**RE: Auto Masters Shop Addition  
2925 Juan Tabo Blvd NE  
Grading Plan  
Engineer's Stamp Date: 03/06/18  
Hydrology File: H21D052**

Based upon the information provided in your submittal received 03/09/18, the Grading Plan **is not** approved for Building Permit. The following comments need to be addressed for approval of the above referenced project:

C-100

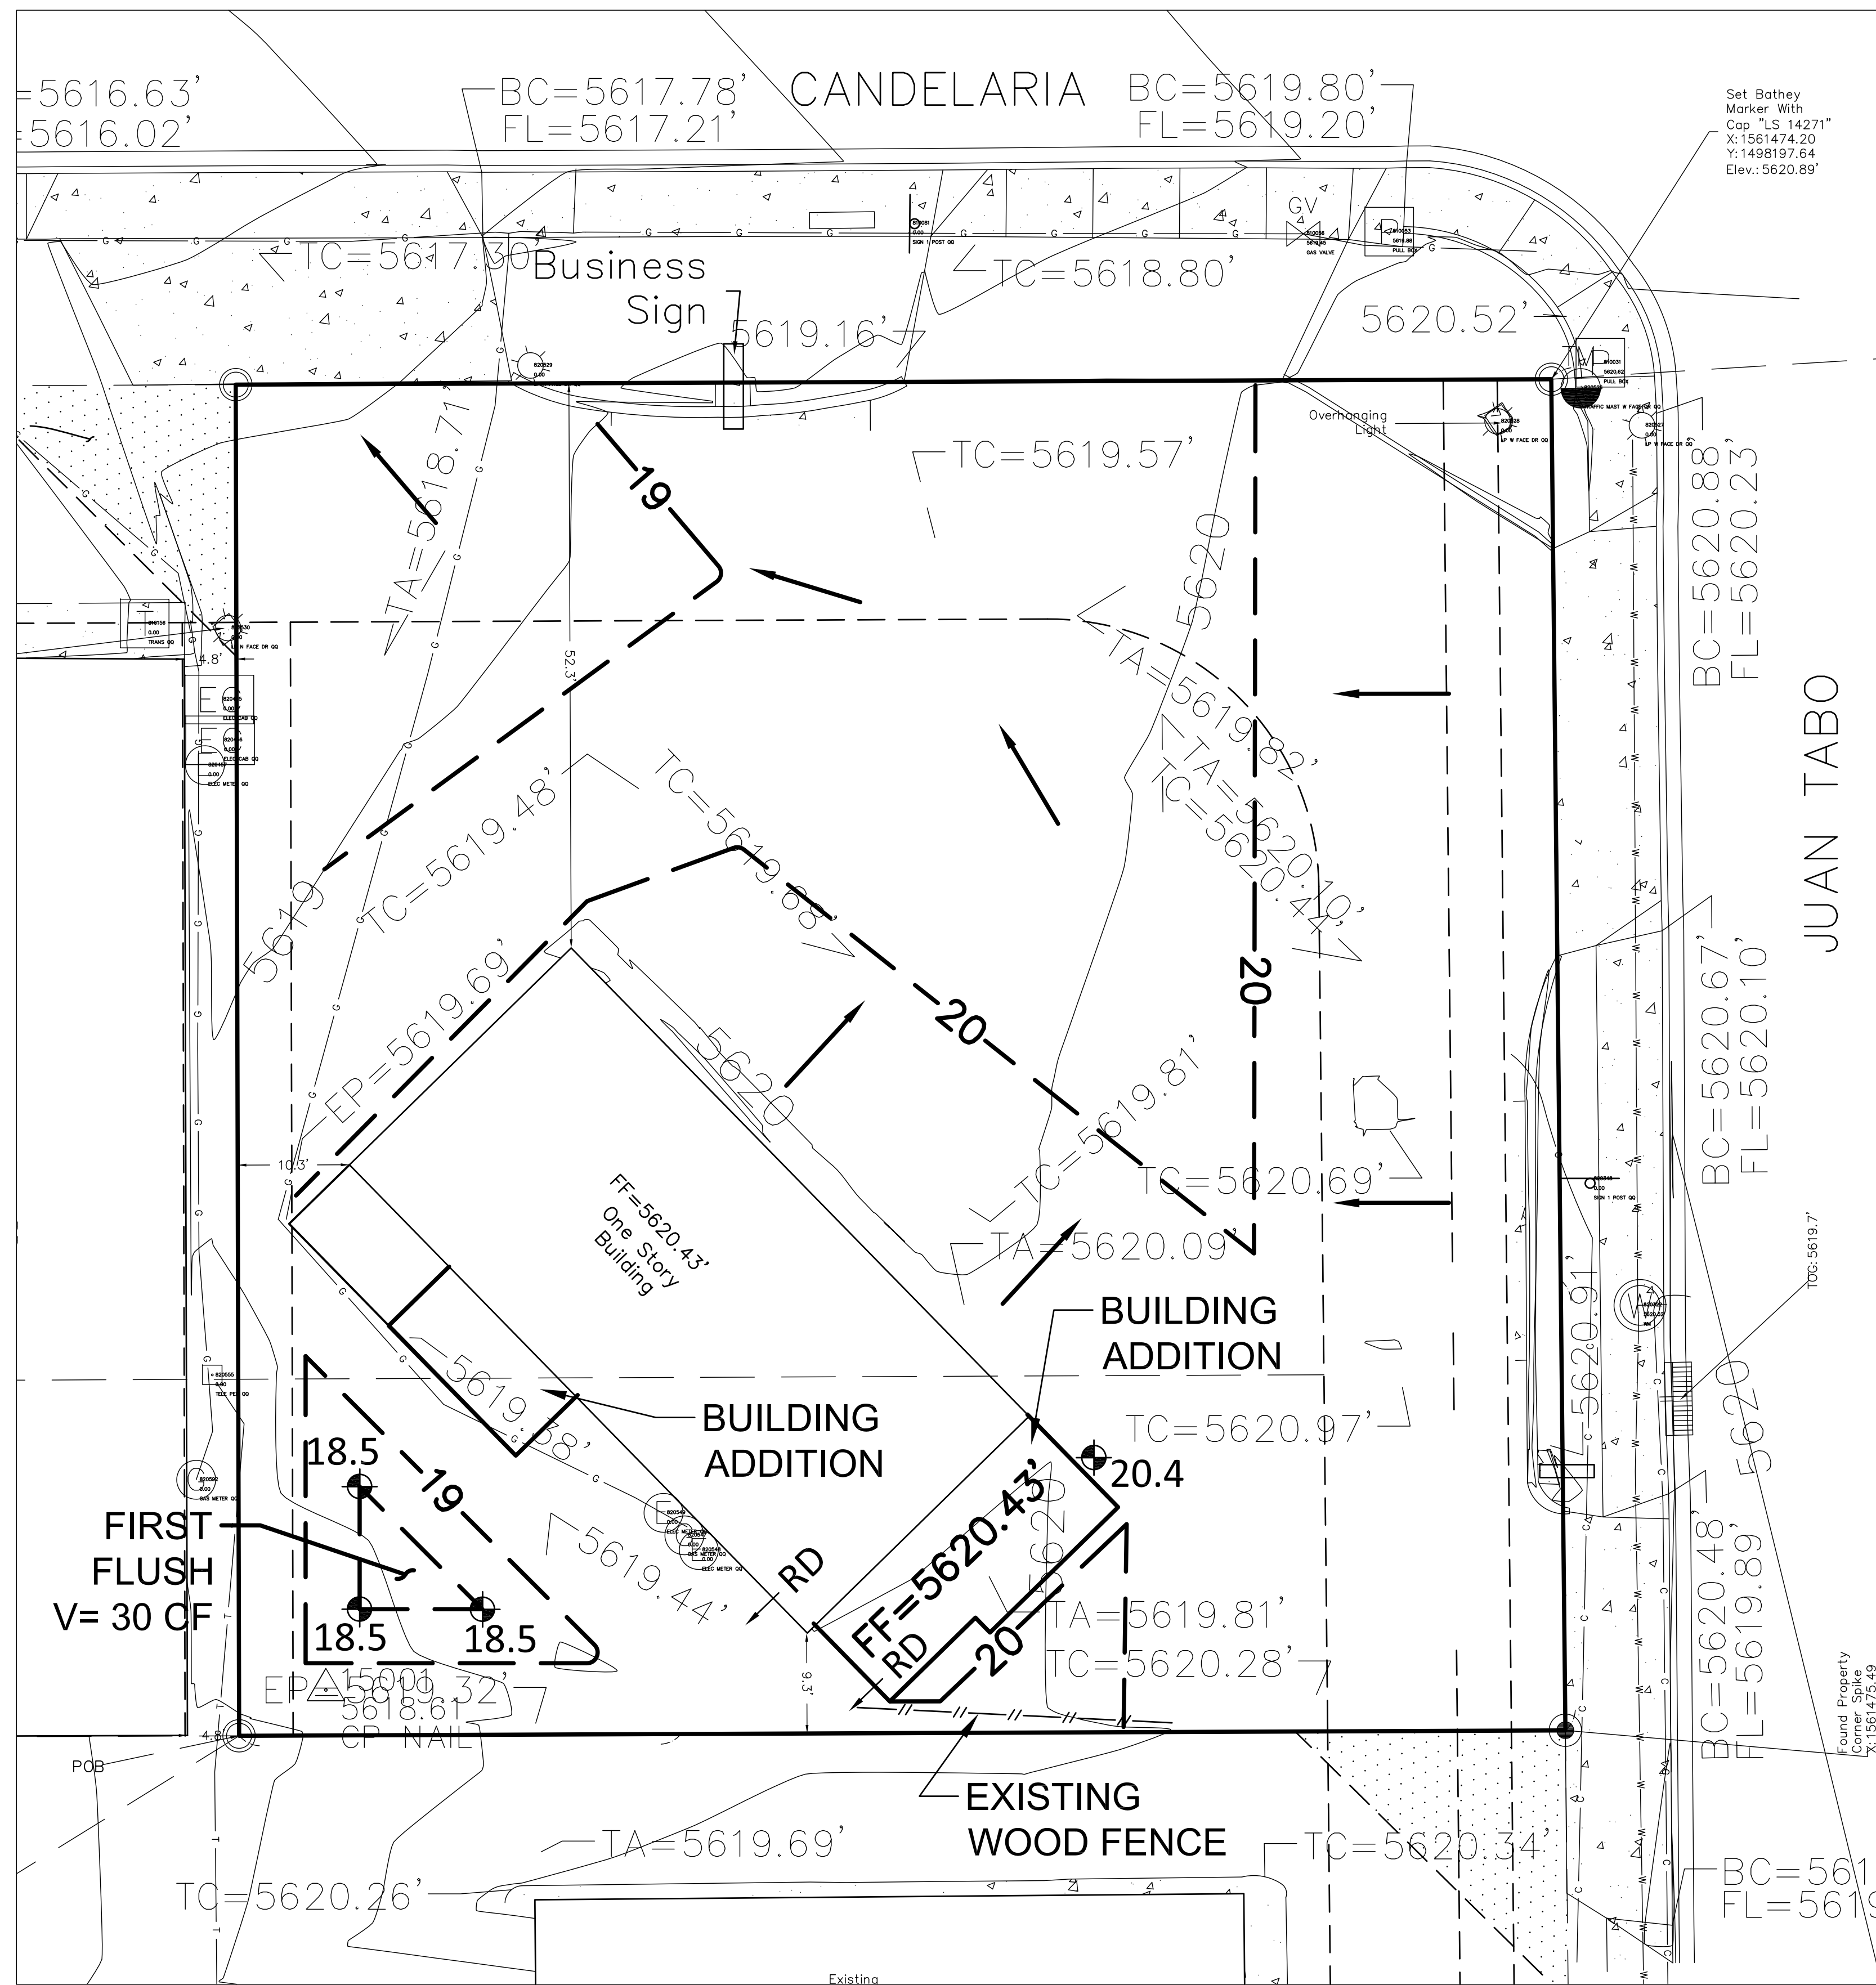
1. Please provide top of curb elevations for the proposed curb at the modified drive on Juan Tabo and add a few more "Match exist. TC/FL" notes where proposed curb is tying into an existing curb.

Please provide a Private Facility Drainage Covenant per Chapter 17 of the DPM for first flush pond prior to Certificate of Occupancy. I have attached a blank copy of this for your use.
